AGENDA FOR THE CANTERBURY BANKSTOWN LOCAL PLANNING PANEL MEETING

2 March 2020 - 6.00pm

1 5 French Avenue, Bankstown

Section 4.55(2) Modification: Minor extensions to Level 01 retail area 3

Figure 1

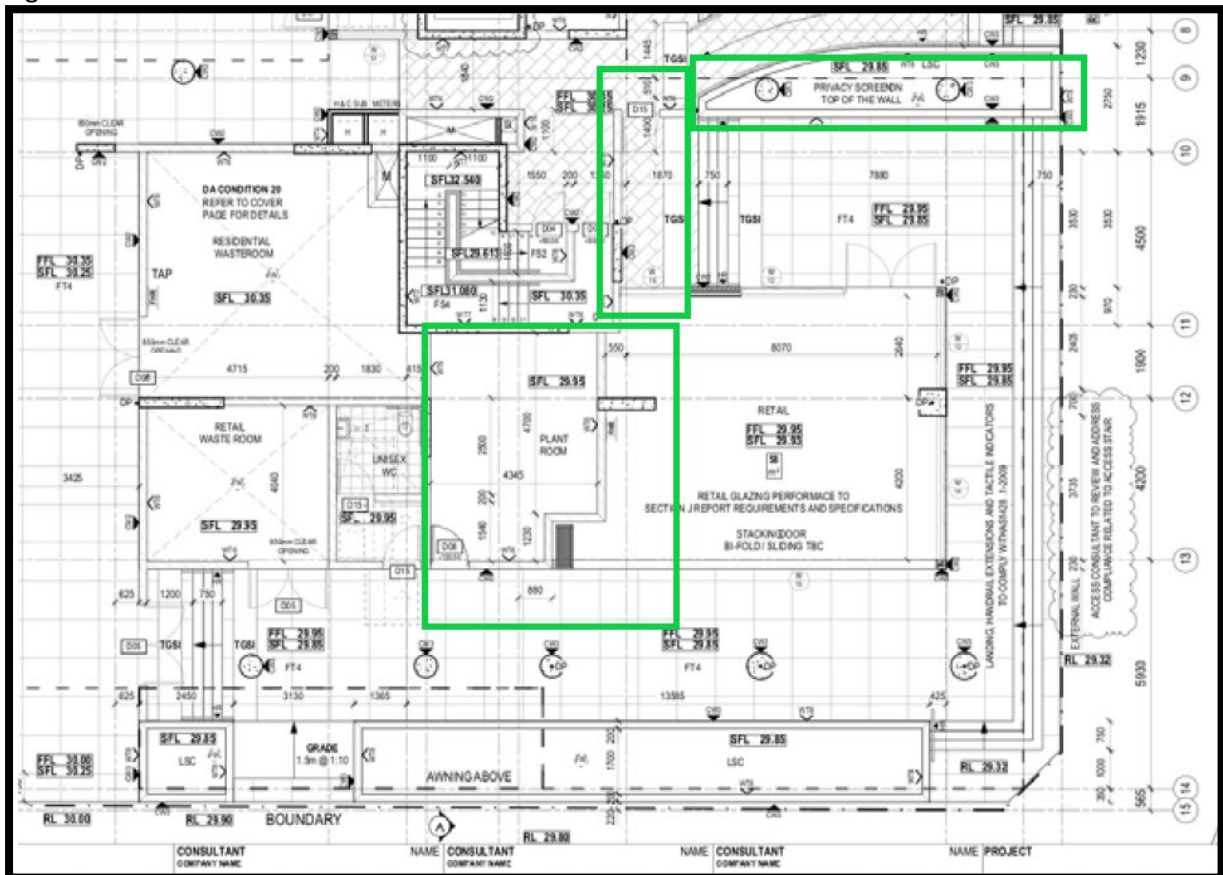
The above excerpt from the CC drawings provided notes the location of a privacy screen to be provided on the planter box edge to the north of the commercial tenancy. Instead a solid wall has been constructed. The solid wall proposed for the fire stairs on the western edge of the area has been lengthened and the solid wall on the north of the commercial tenancy extends to align with the fire stairs, and a single access door has been installed to the western wall. The CC plans show the construction of a plant room adjoining the commercial tenancy. This has not been constructed, rather forms part of the commercial tenancy.

Figure 2

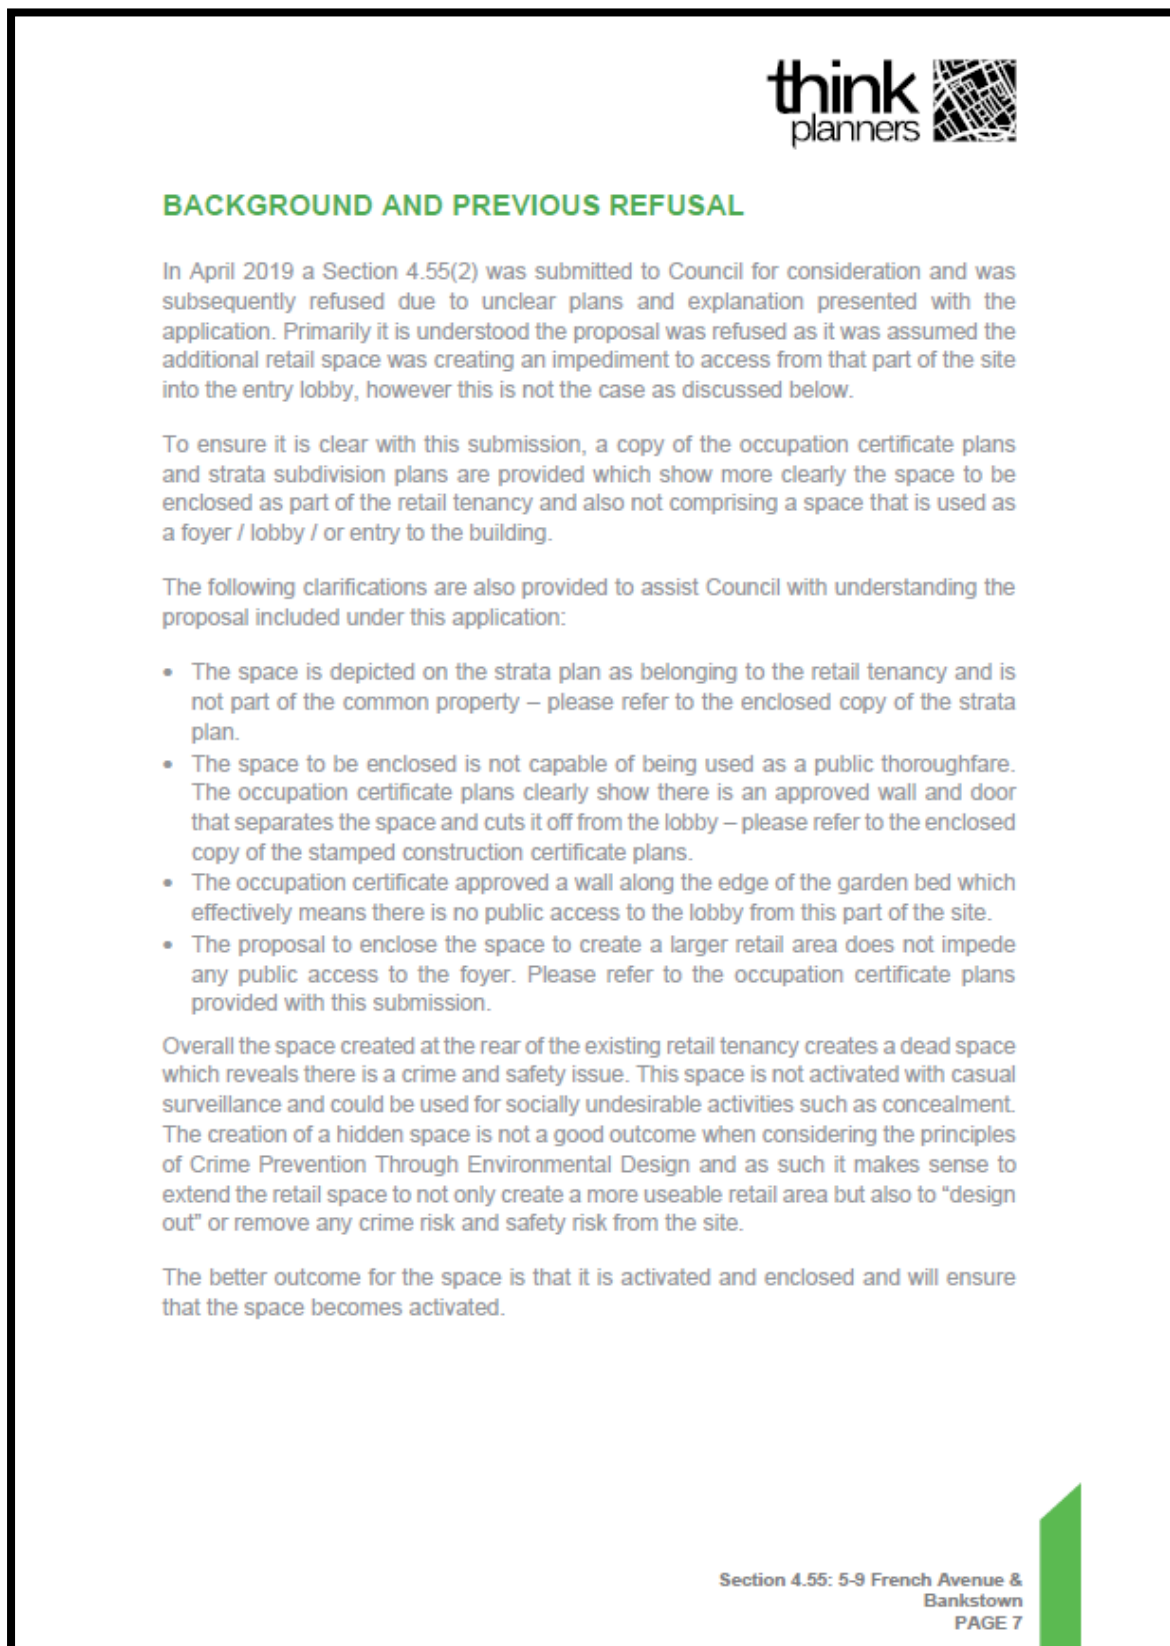
The SEE provides a list of points to clarify Council’s understanding of the proposal. The SEE notes that the space to be enclosed is not capable of being used as a public thoroughfare resulting from the occupation certificate plans. The construction certificate plans submitted

do note this area to have the installation of a privacy screen to the north of the commercial tenancy on top of the planter box, however a solid wall has been constructed and the rear (western edge) of the area enclosed with a solid wall along the fire stairs. Neither of which were approved on the DA plans.

The construction certificate plans submitted are not consistent with what has been constructed on site for this area and the commercial tenancy. The SEE notes that the “*Overall the space at the rear of the existing retail tenancy creates a dead space which reveals there is a crime and safety issue*”. The creation of the dead space is a result of non-compliance with the approved DA plans and results in a less than desirable built form outcome on the site.

The inconsistency of the construction certificate drawings with the approved plans is a matter for the certifier and does not lend to providing a basis for Council to support a variation to its controls in relation to FSR or endorse a design that is a less desirable outcome for the development as a whole.

Image 3 – Excerpt of floor plan noting walls already built in green box

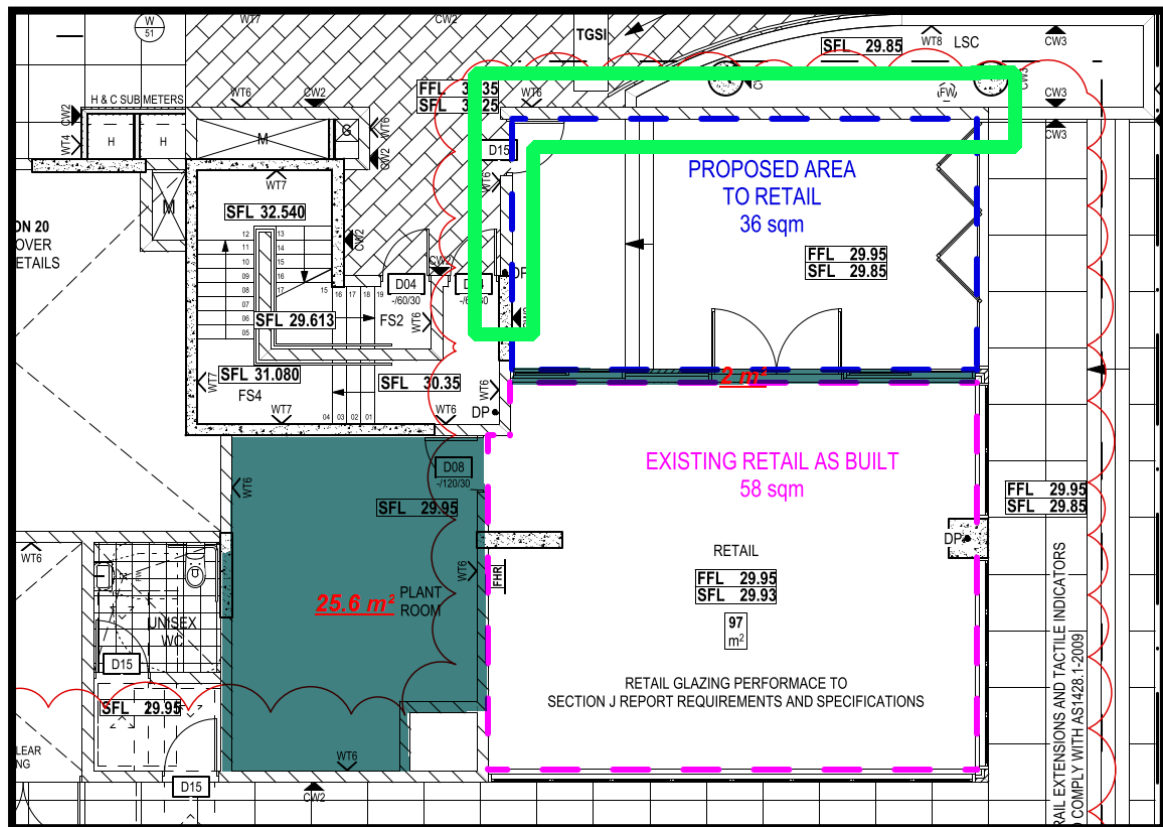
Inspection of the site has shown that building works have occurred that are not consistent with the approved plans (as modified). The ground floor plant room has not been constructed and now forms part of the approved commercial tenancy. A solid wall has been built to the north of the commercial unit partially enclosing the area proposed to be extended as part of the commercial tenancy.

The 'plant room' approved to the west of the commercial area, now results in an additional 25.6sqm of floor space that has not been accounted for in the gross floor area calculations of the development. The issue of the plant room was raised with the applicant who has advised that the plant room wall between the commercial tenancy and the plant room is not required at present and will be built once a tenancy use is identified. This is not considered a viable or likely occurrence, given the building is at completion and 'plant' to facilitate a commercial tenancy cannot be retrofitted in a way that isn't considered floor area.

Accepting the as constructed calculations provided, with the addition of the ground floor extension proposed and the 'plant room', the proposal results in a FSR of 3.508:1 across the site.

The proposed extension of the commercial space to the north of the approved retail area seeks to extend into a portion of the approved ground floor undercroft that contains a level change to the rear 12sqm (steps within) and a rear access door to the residential interface of the building. The undercroft as approved with the level change
